Amendment Notice #3

| Licence Number | L8621/2011/1 |
| Licensee | Roy Hill Iron Ore Pty Ltd |

This notice is limited only to an amendment for construction and operation of a new diesel-fired power station, new in-pit tyre disposal area and additional ore crushing and screening facilities.

Roy Hill Iron Ore Mine – Power Station

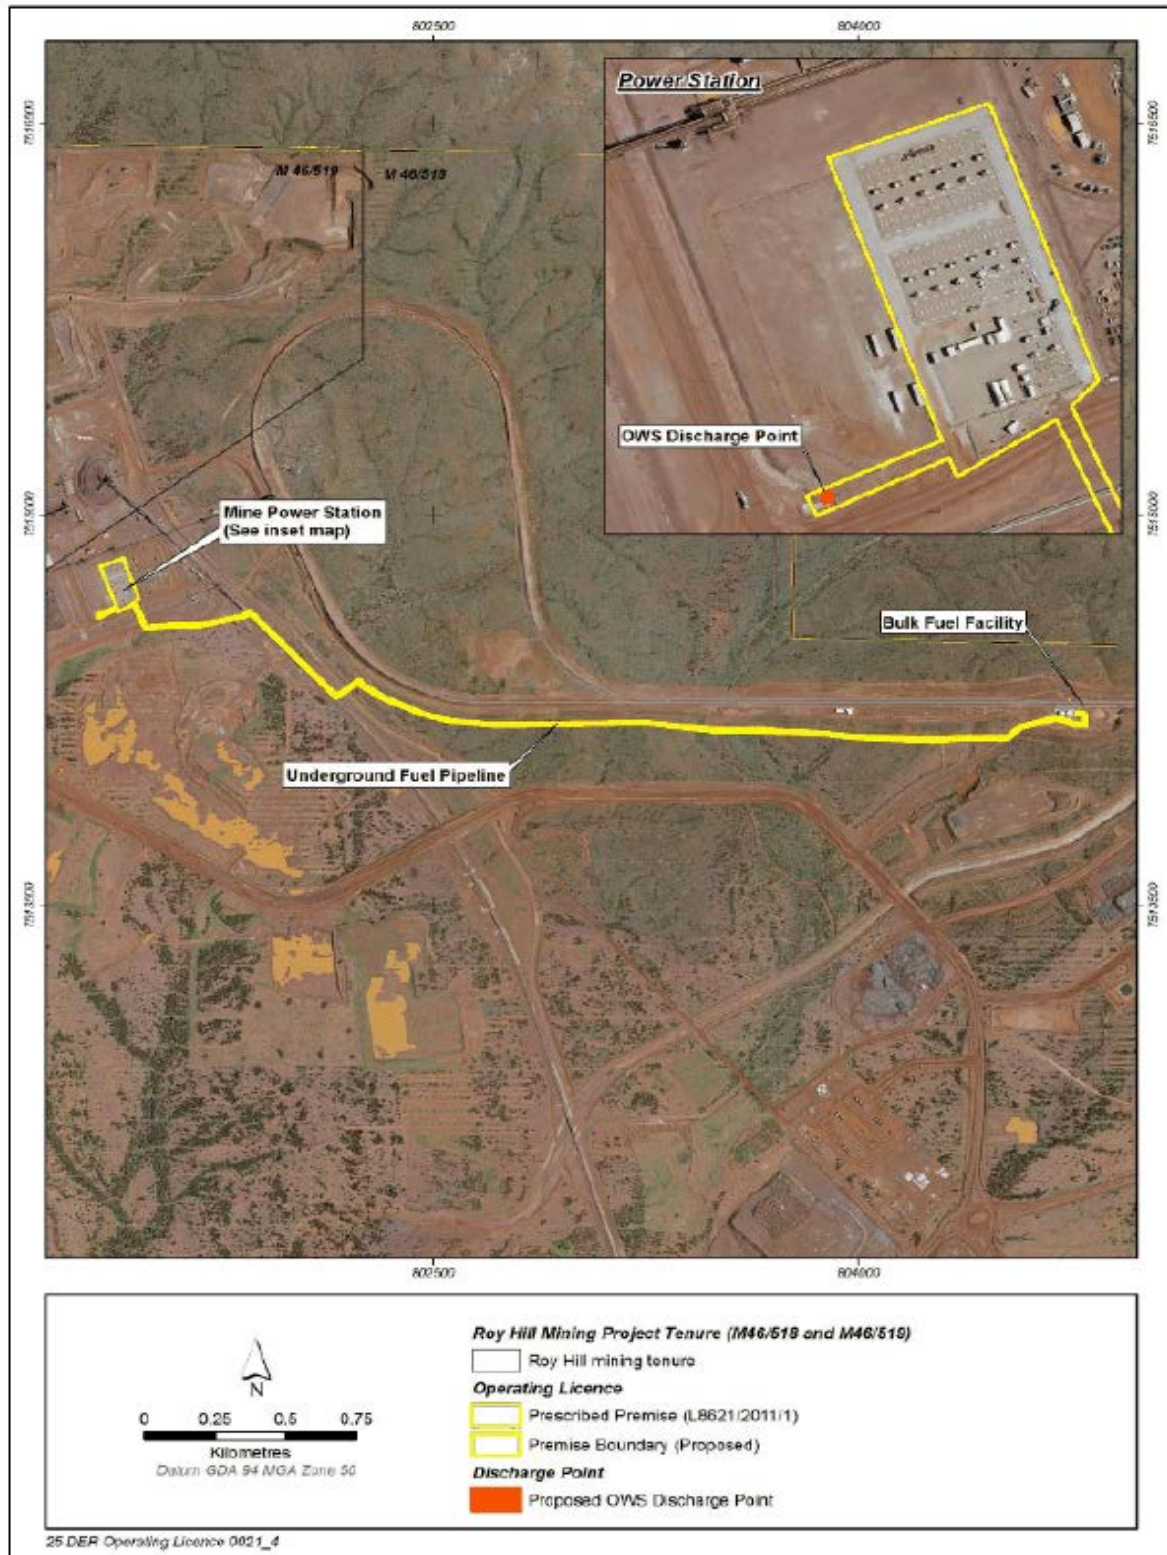
| <u>OWS discharge location (at Power Station as shown in Attachment 2)</u> | <u>Discharge of treated water from the OWS at the Power Station to the Premises stormwater system that discharges to the environment</u> | <u>Water that has been treated through the OWS to the environment via a sediment trap</u> |

| Table 2.3.2: Emission limits to land | | | |
|---|--------------------------------|--------------------------------|-------------------------|
| <u>OWS discharge location (at Power Station as shown in Map in Attachment 2)</u> | | | |

| <u>OWS discharge location (Power Station as shown in Attachment 2)</u> | | | | |

Roy Hill Iron Ore Mine – Power Station Layout

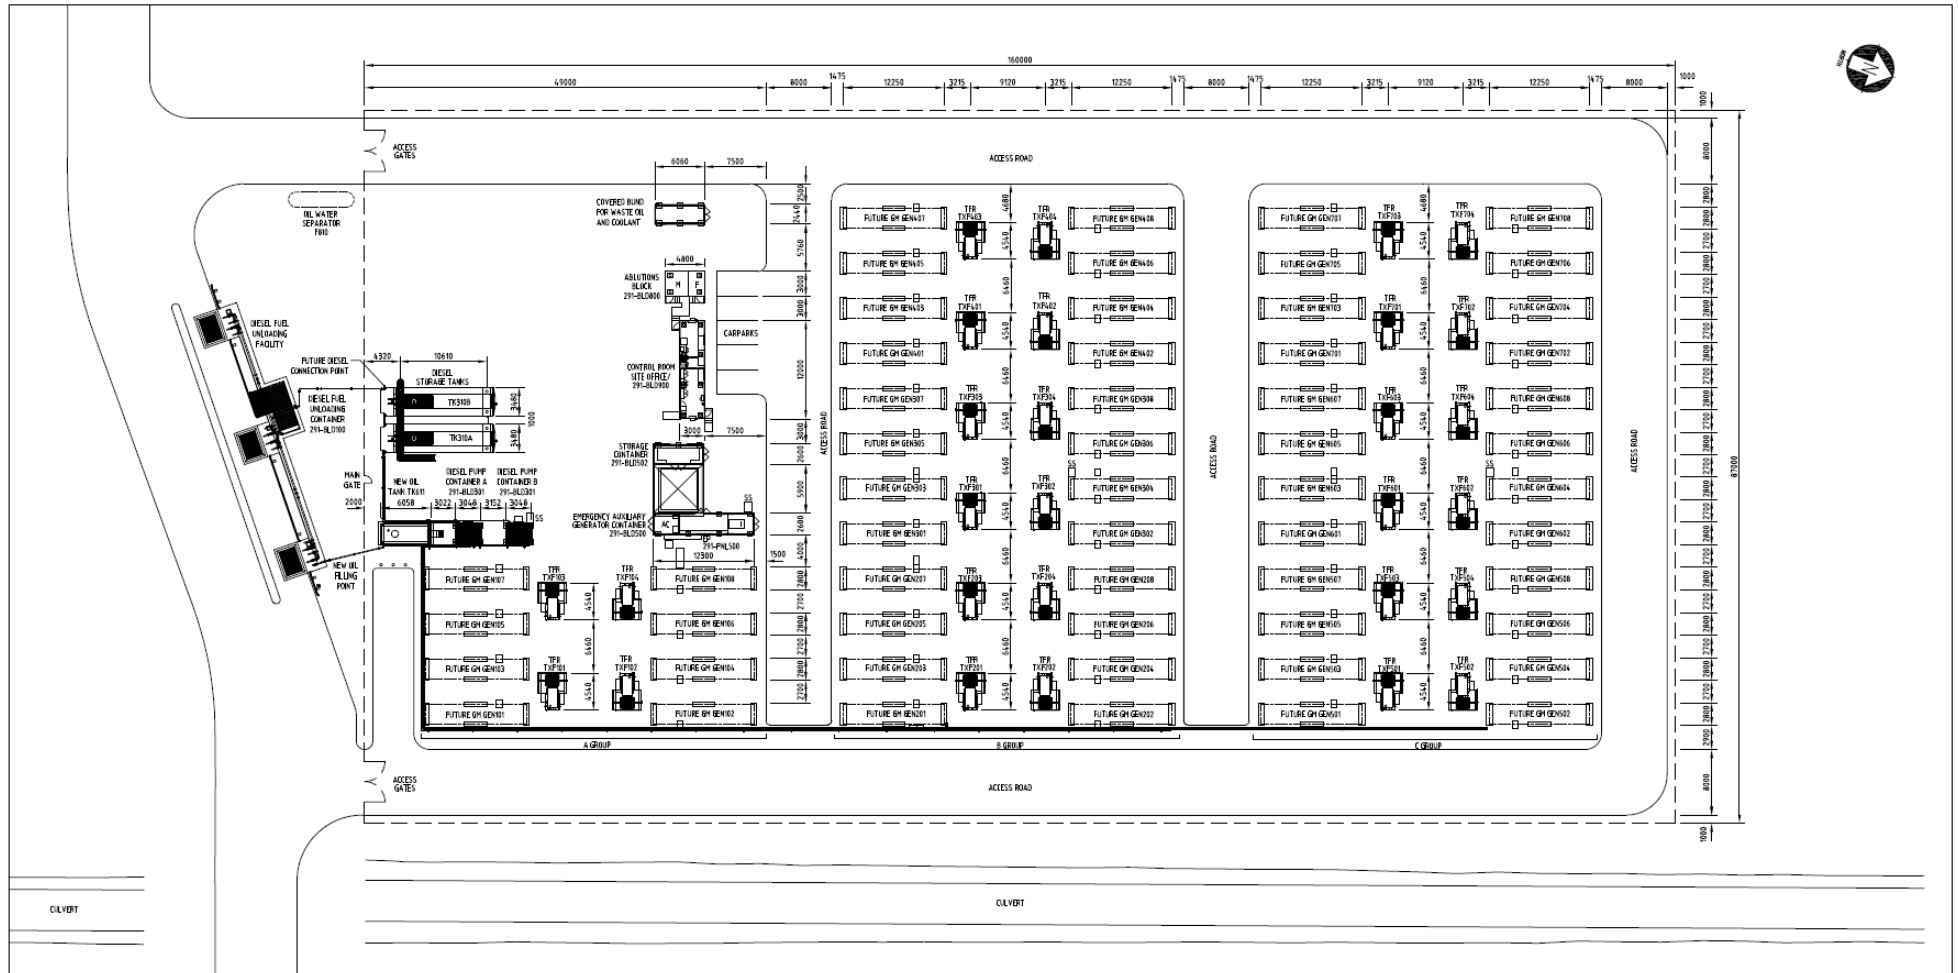
Diesel fuel will be supplied to the power station via an existing underground diesel pipeline, which runs from the mine site Bulk Fuel Facility to the two power station diesel storage tanks. Diesel fuel can also be delivered by road tanker to a diesel unloading facility located just outside the power station boundary. Attachment 2 depicts the location of the power station relative to the underground pipeline and mine site Bulk Fuel Facility. Attachment 3 shows the layout of the power station.

Roy Hill Iron Ore Mine – location of In-pit tyre disposal areas

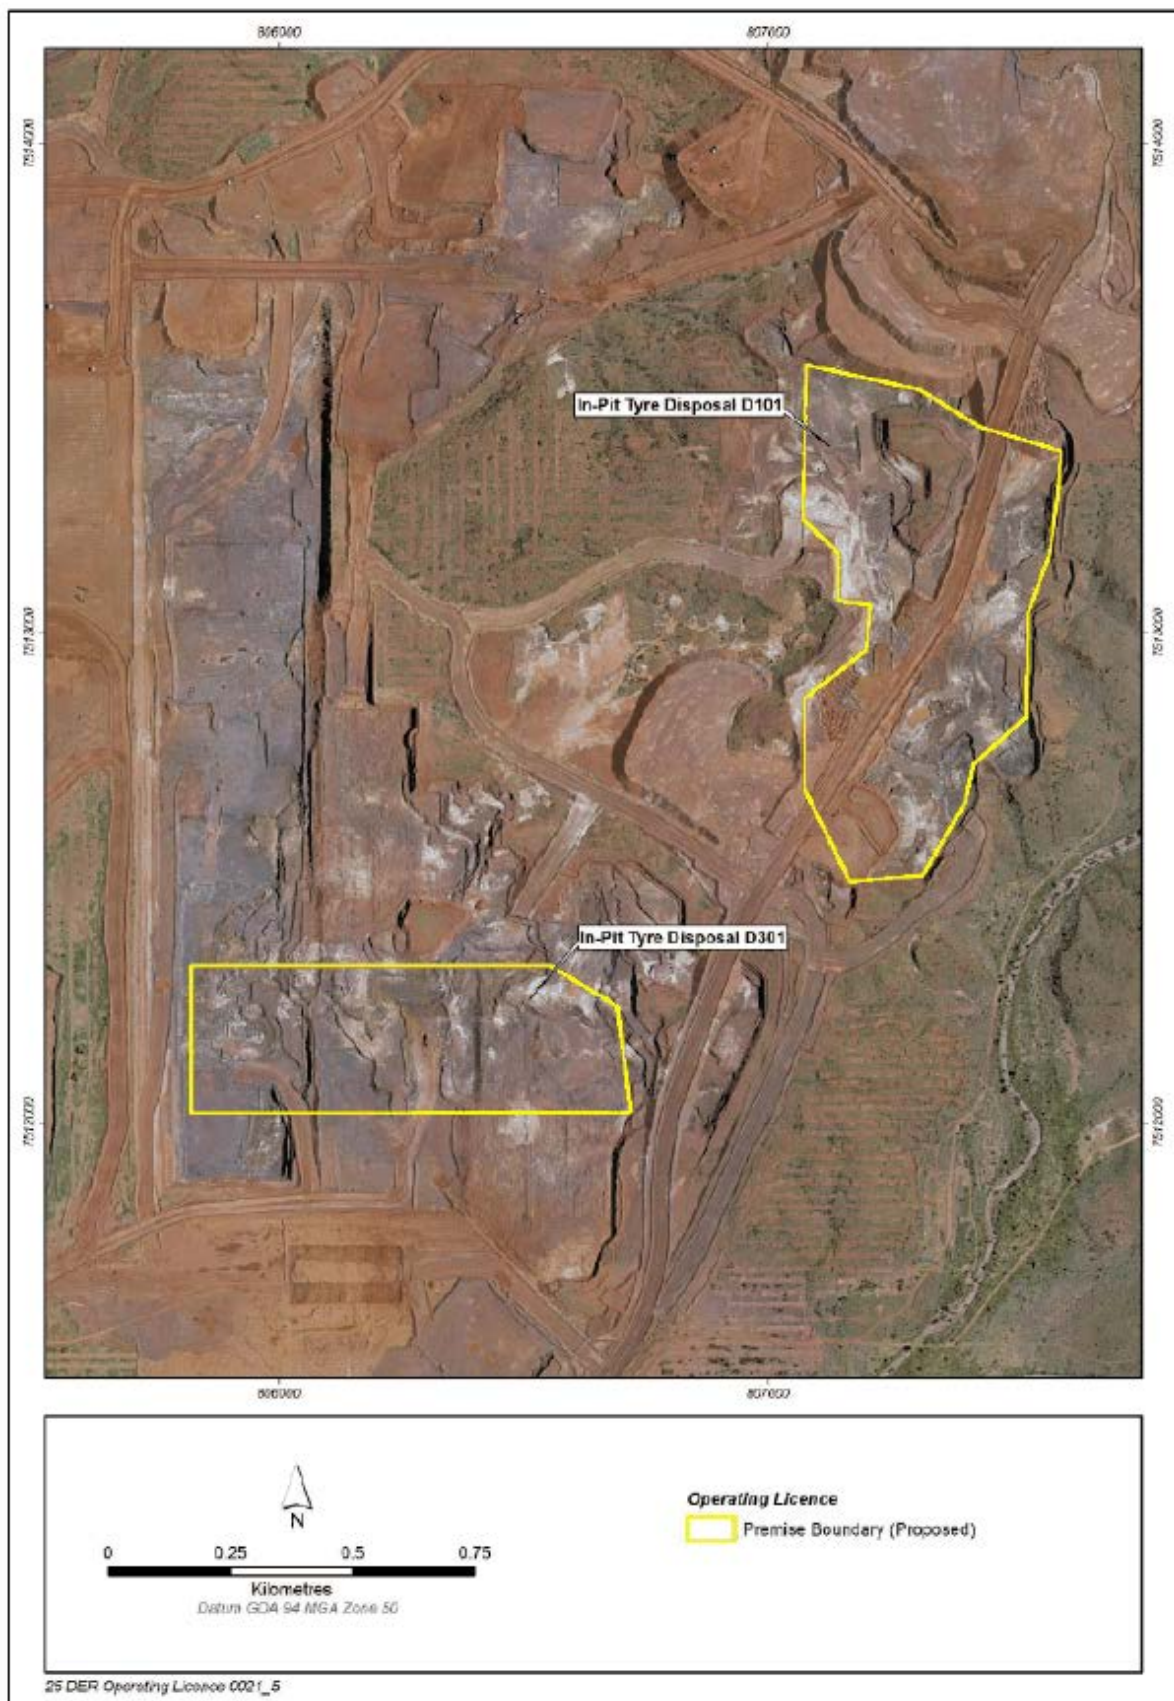
| Table 1.3.6: Works specifications | |
|--|---|
| <u>In-pit tyre disposal area</u> | <ol style="list-style-type: none"> <u>To be located within Delta Mine Pit as per Attachment 4 titled "Roy Hill Iron Ore Mine - In-pit Tyre Disposal Locations"; and</u> <u>Base of tyre disposal area to be at least 3m above original groundwater level</u> |
